# Technical Service Information

## THM 200C

### LOCK-UP RIGHT ON TOP OF 2-3 SHIFT

Figure 1

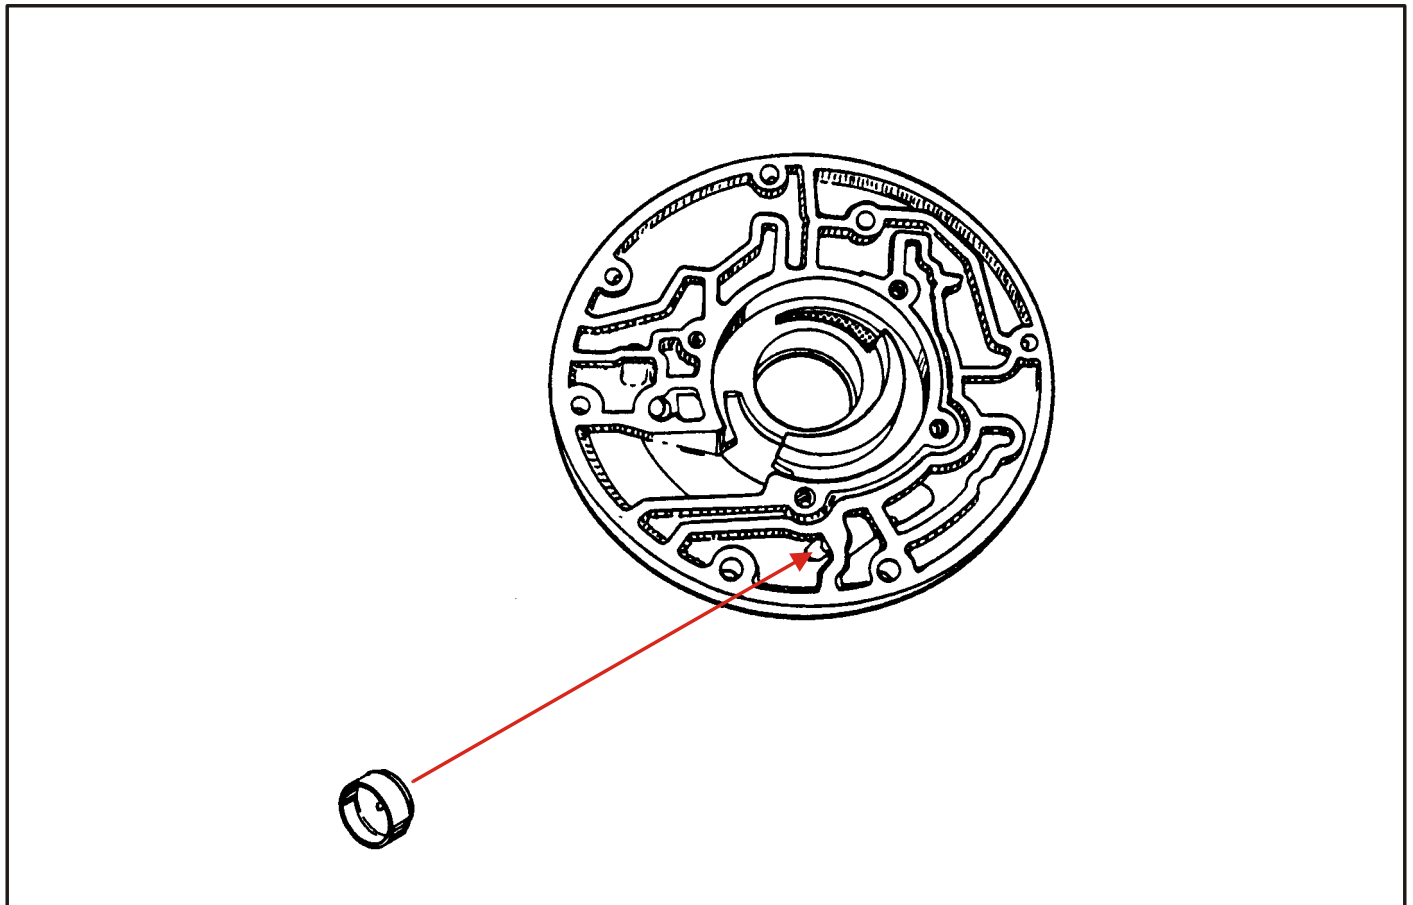
**COMPLAINT:** Converter clutch engages immediately after the 2-3 shift occurs.

The cause may be the orifice cup plug missing from the pump body (See Figure 1). If this cup plug is missing, direct clutch oil will overrun the solenoids ability to exhaust, and stroke the lock-up valve on the 2-3 shift. If the orifice is blocked, or a solid cup plug is installed, you will have NO lock-up

Install orifice cup plug in the pump body in the location shown in Figure 1. The cup plug is available under OEM part number 8630529.
